DIST	COUNTY	ROUTE	KILOMETER POST TOTAL PROJECT	SHEET No	TOTAL SHEETS
04	SF	80	13.2/13.9	91R1	1204

REQUEST FOR INFORMATION NOT ADDRESSED IN THIS CCO REMAIN IN FORCE

MARK	DATE	DESCRIPTIONS	BY	CH'D	CCO#
		REVISIONS			
1	02/19/08	ELECTRICAL MODIFICATIONS	MP EL	RR	42

STATE OF CALIFORNIA - DEPARTMENT OF TRANSPORTATION
Caltrans
DESIGN OVERSIGHT
BEHZAD GOLEMOHAMMADI

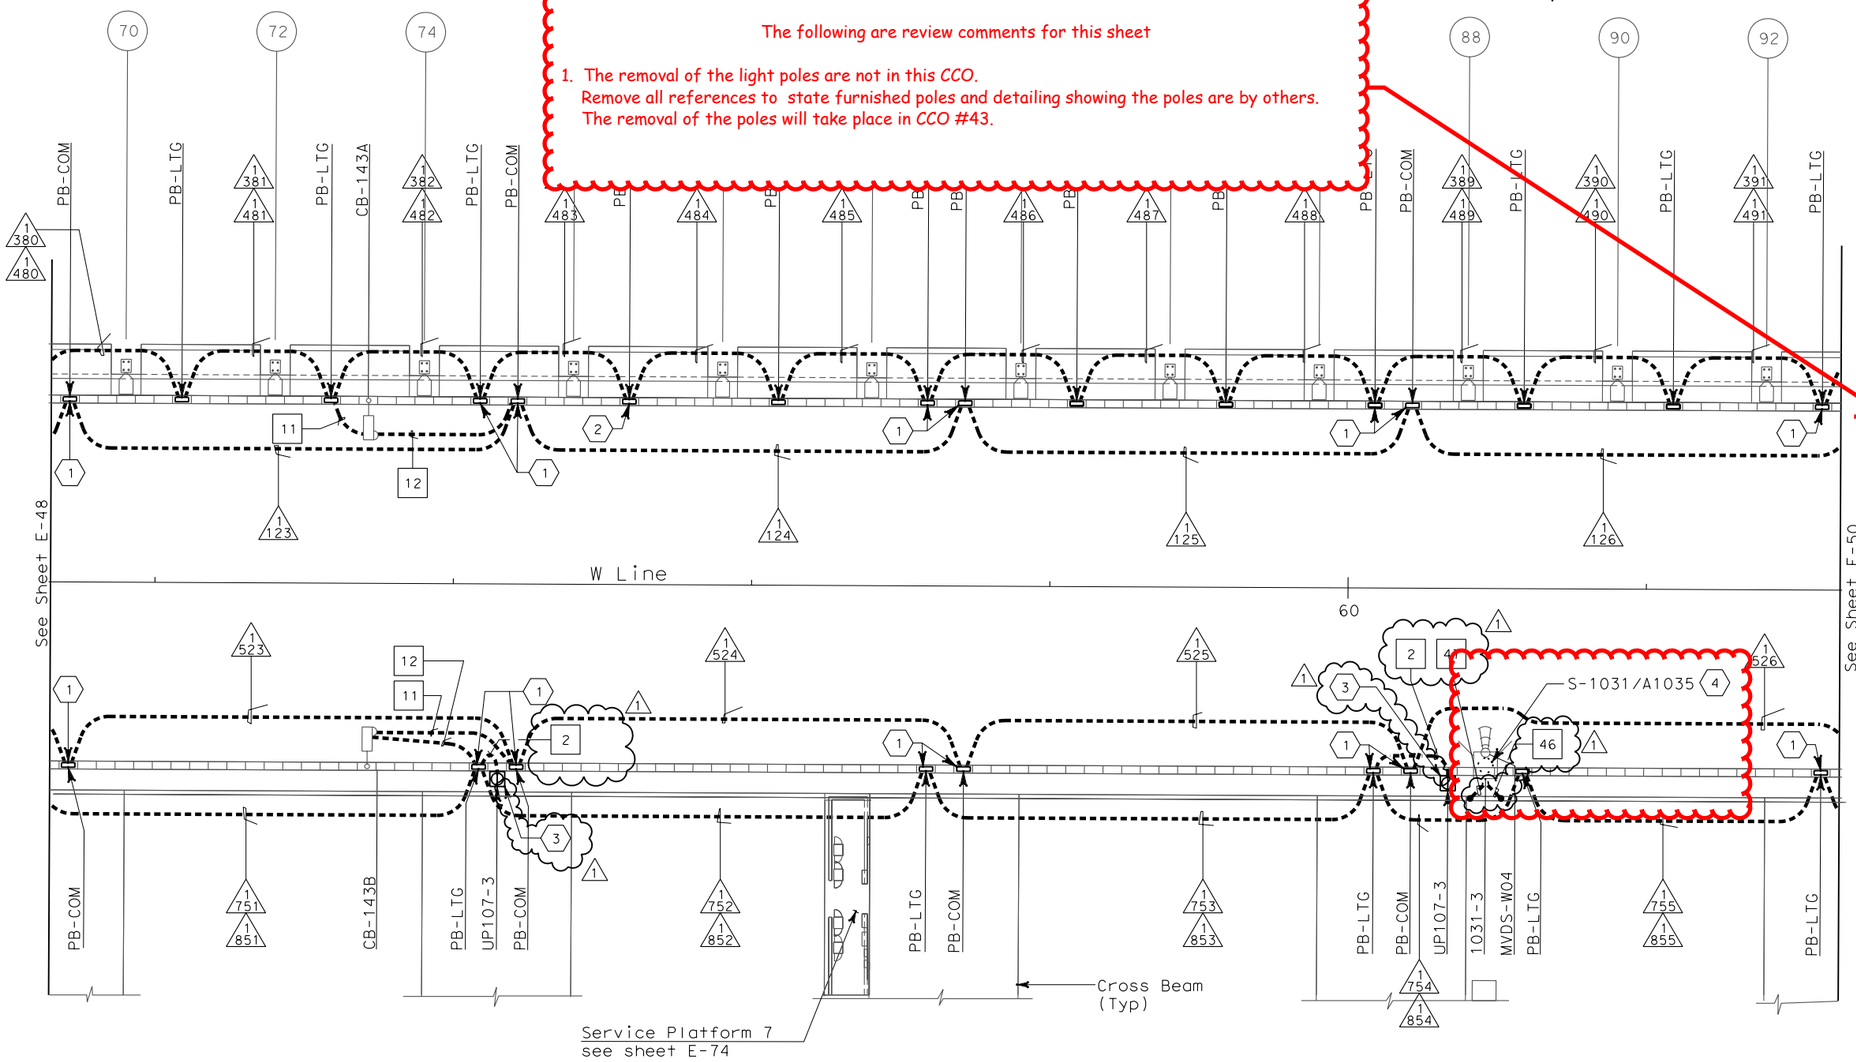
1. The removal of the light poles are not in this CCO.
   Remove all references to state furnished poles and detailing showing the poles are by others.
   The removal of the poles will take place in CCO #43.

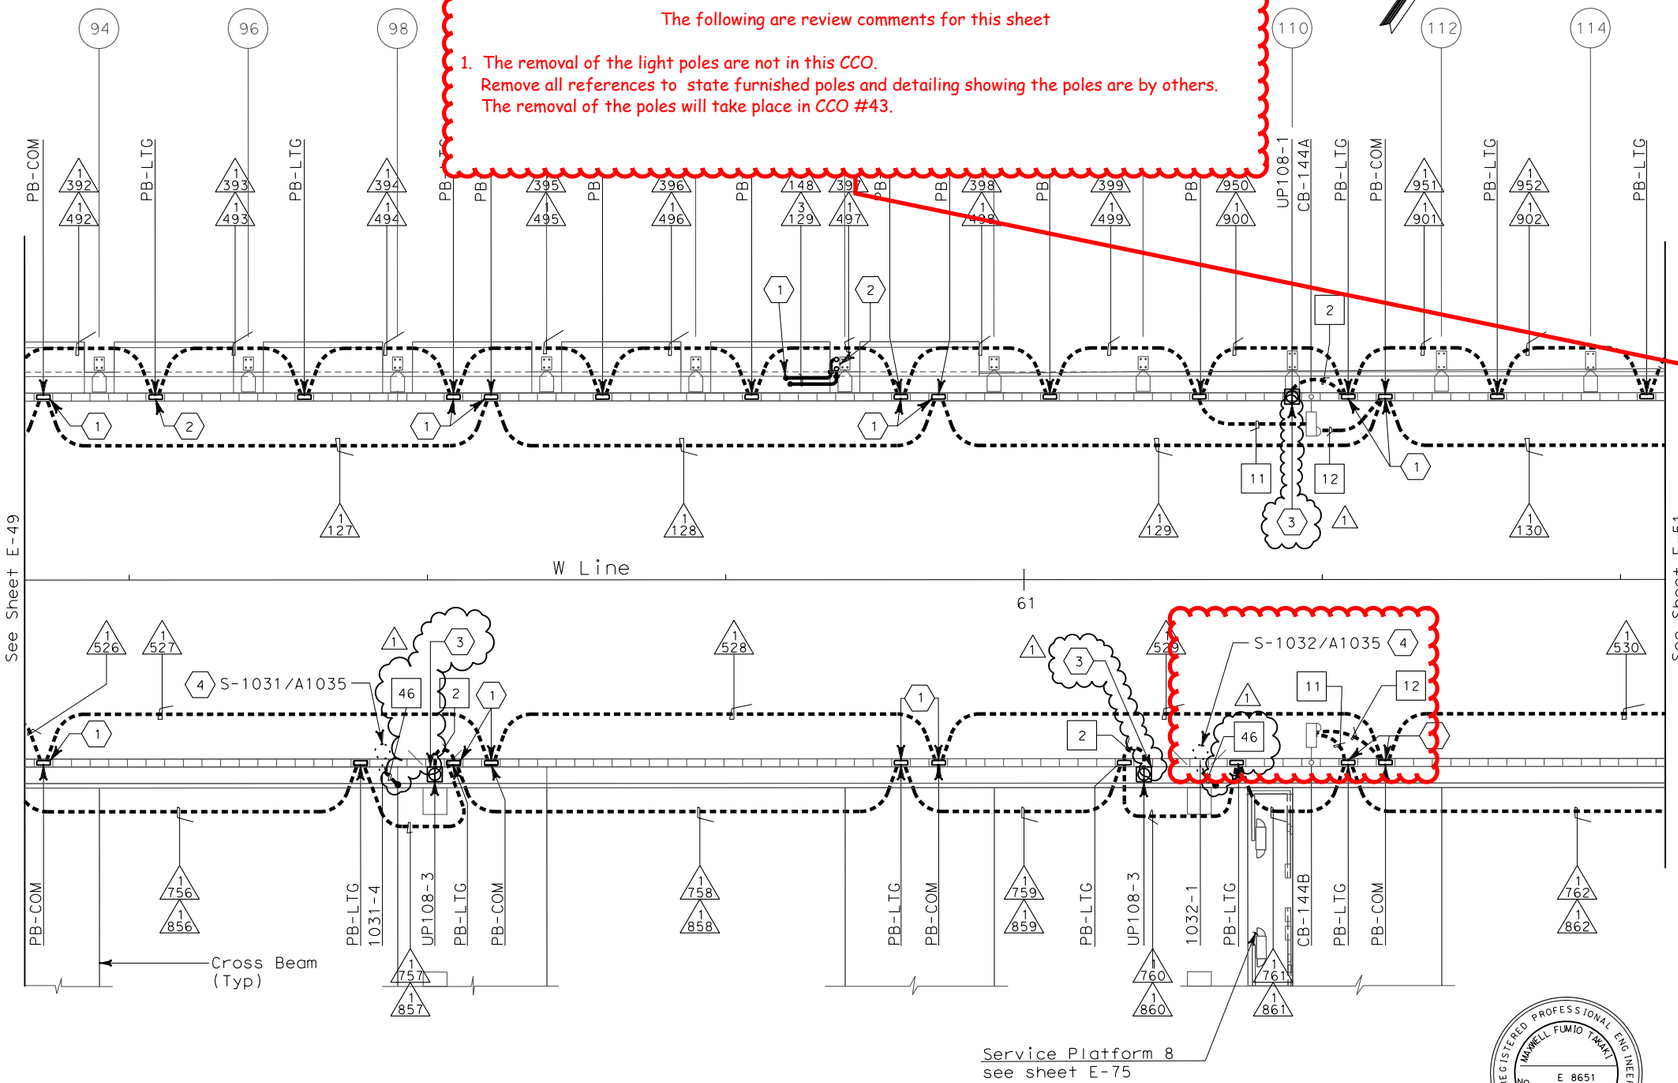
1. The removal of the light poles are not in this CCO.
   Remove all references to state furnished poles and detailing showing the poles are by others.
   The removal of the poles will take place in CCO #43.

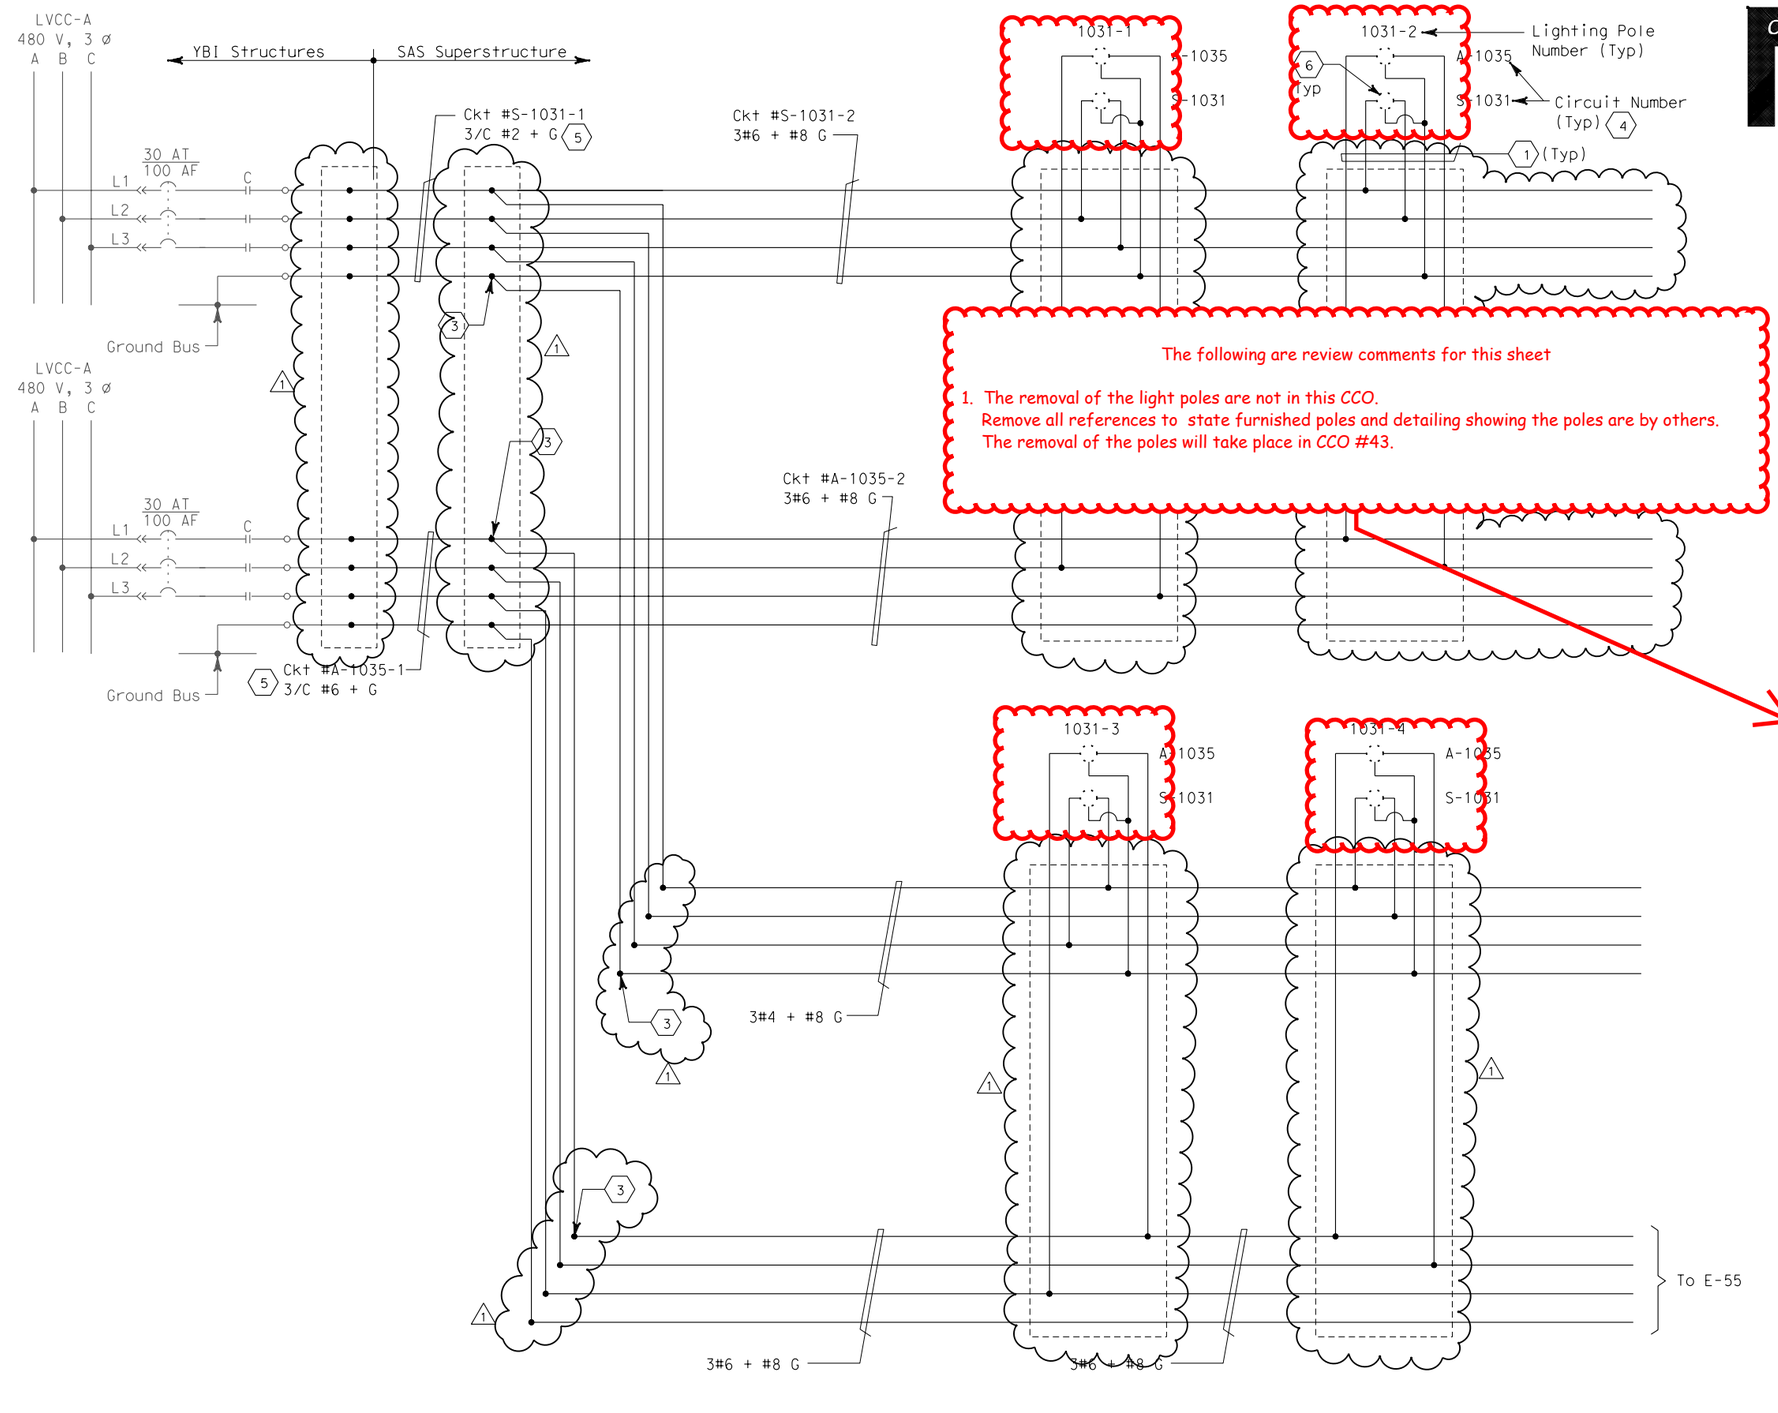
The following are review comments for this sheet

1. The removal of the light poles are not in this CCO.
   Remove all references to state furnished poles and detailing showing the poles are by others.
   The removal of the poles will take place in CCO #43.

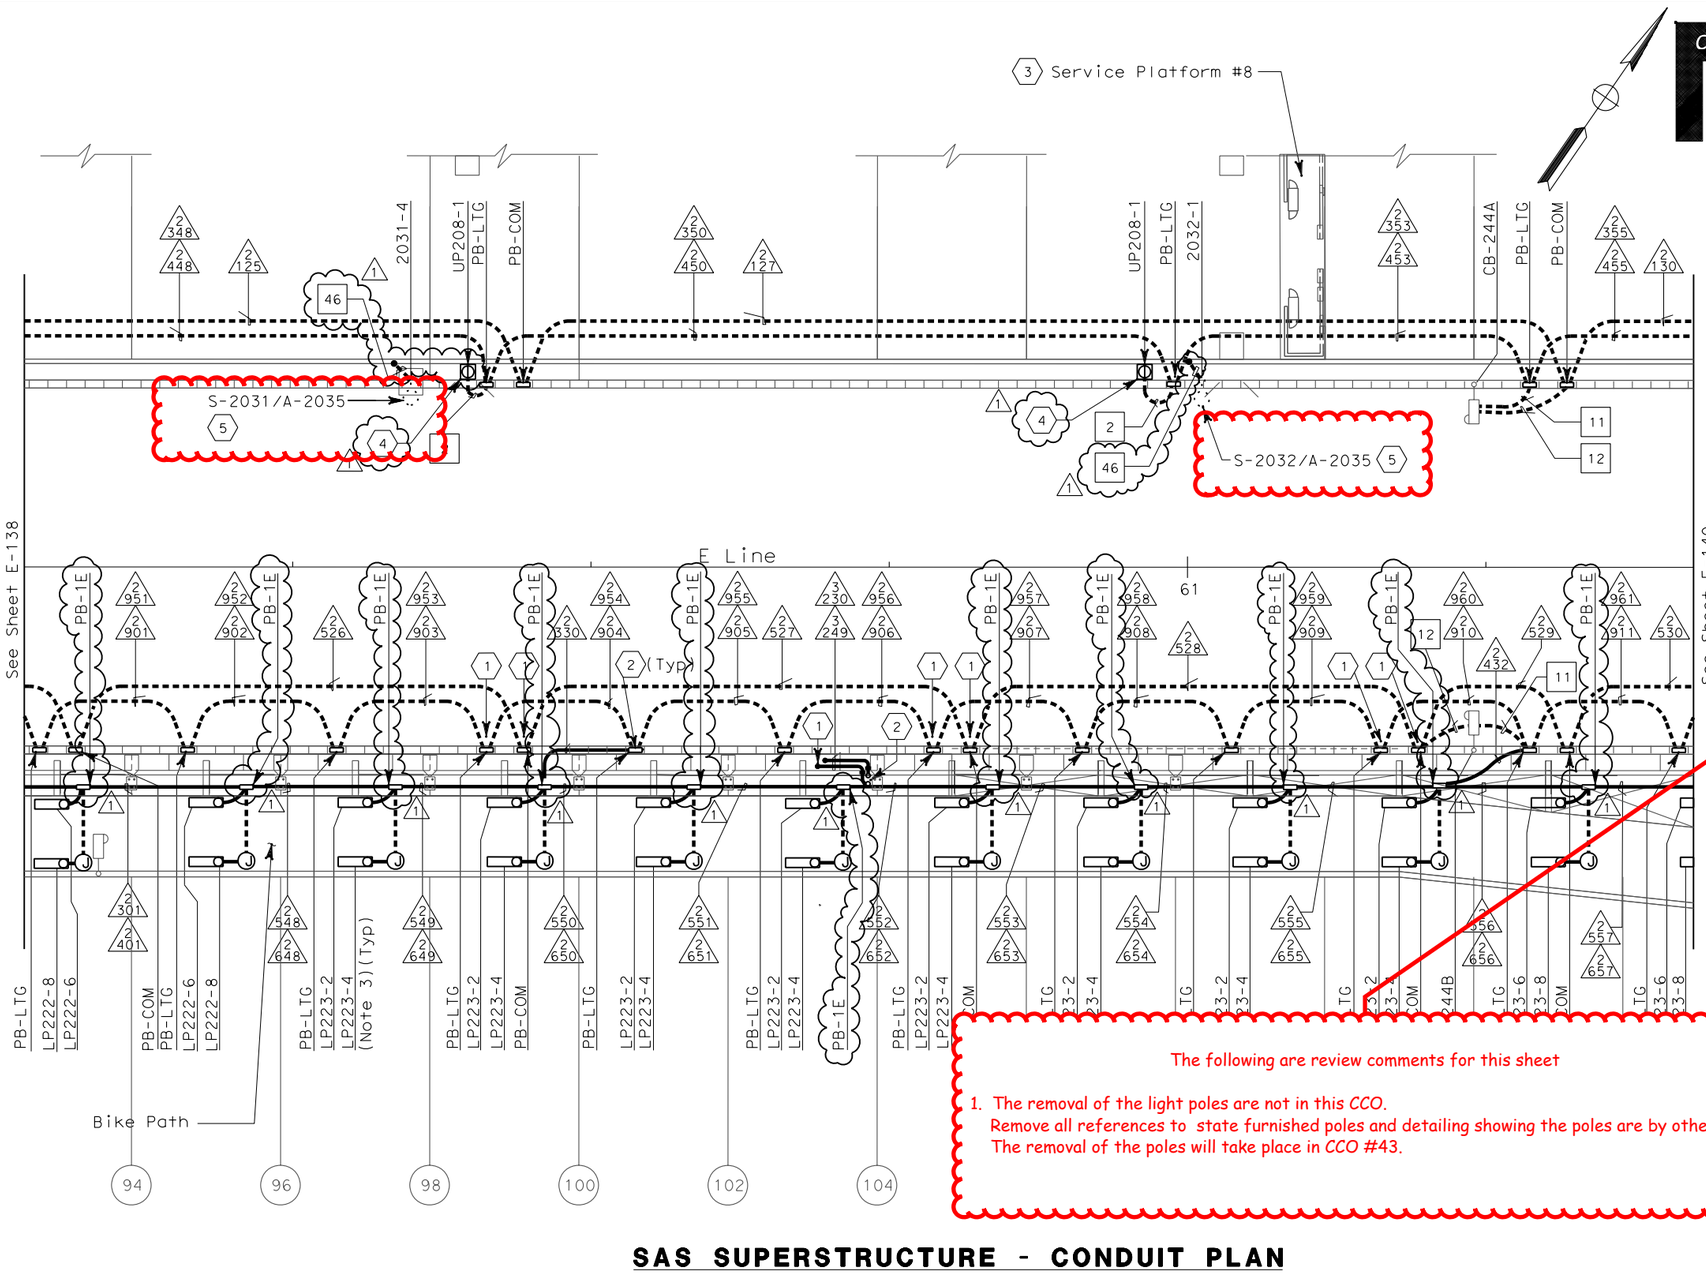
The following are review comments for this sheet

1. The removal of the light poles are not in this CCO.
   Remove all references to state furnished poles and detailing showing the poles are by others.
   The removal of the poles will take place in CCO #43.

SAS SUPERSTRUCTURE - CONDUIT PLAN

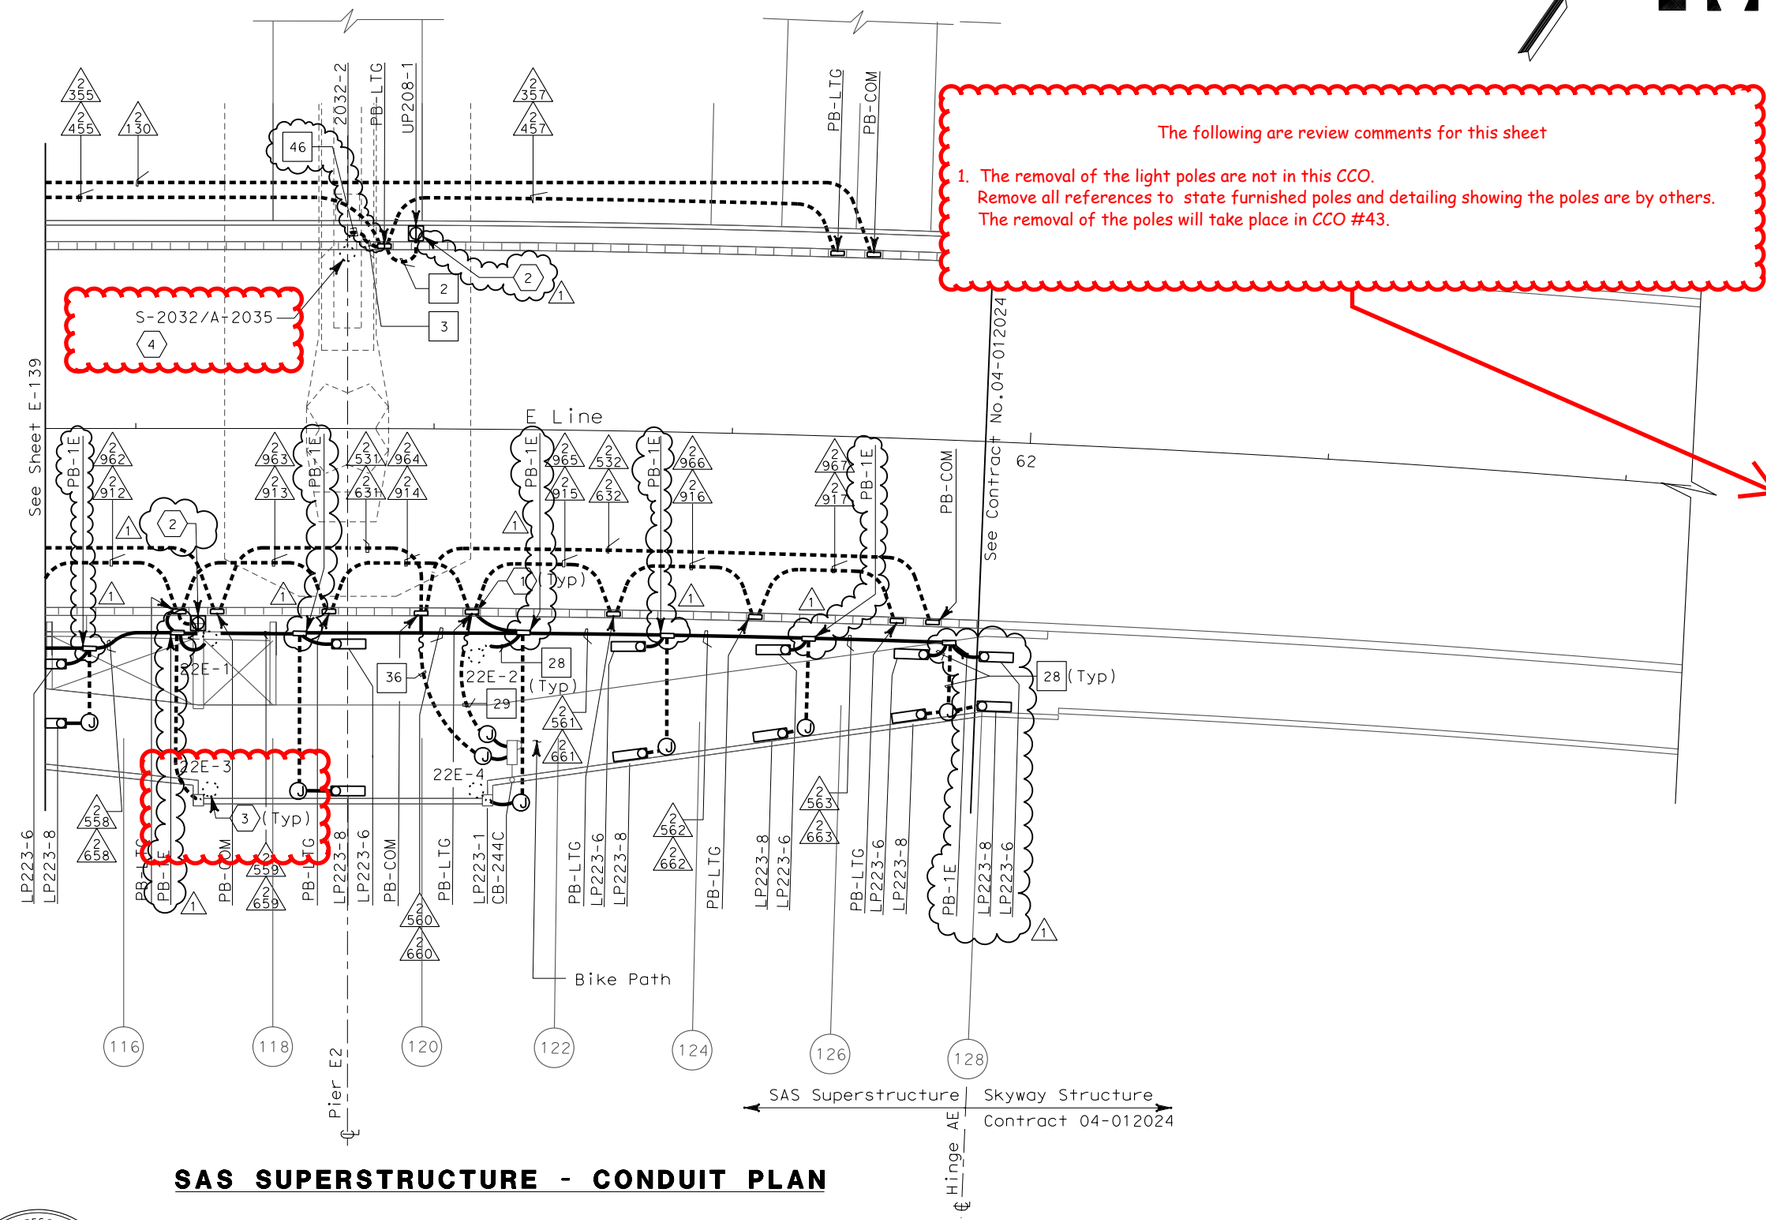
1. The removal of the light poles are not in this CCO.
   Remove all references to state furnished poles and detailing showing the poles are by others.
   The removal of the poles will take place in CCO #43.
